Model	Model Code	Model Type
BF2.3DK2	BAVJ	
BF2DK2	BZBF

Authorized by MATSUMURA HIROYUKI
Power Product Service Engineering Department, Honda Motor Co.,Ltd

Engine Hard Start /Rough Idle and stall

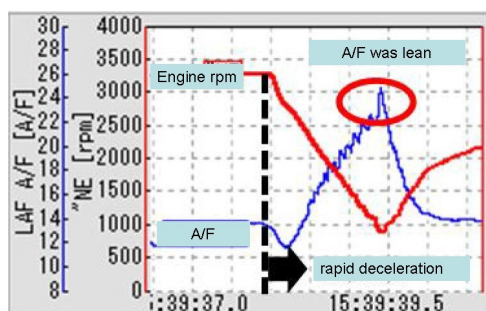
The engine was hard to start and during warm up engine idle was rough then finally engine was stalled.

We found problem which idle and from 3,000rpm decelerating timing A/F was too lean. Throttle valve full close clearance was narrow.

Carburetor specification will be changed(Apply BF2.3 carburetor assy.). Idle A/F specification will be changed as follow,

Idle A/F
Current	17.8+/-2.7
Countermeasure	15.6+/-2.3

In case customer complaint rough idle or engine stall symptom please make sure symptom then replace whole carburetor assy. please refer shop manual.
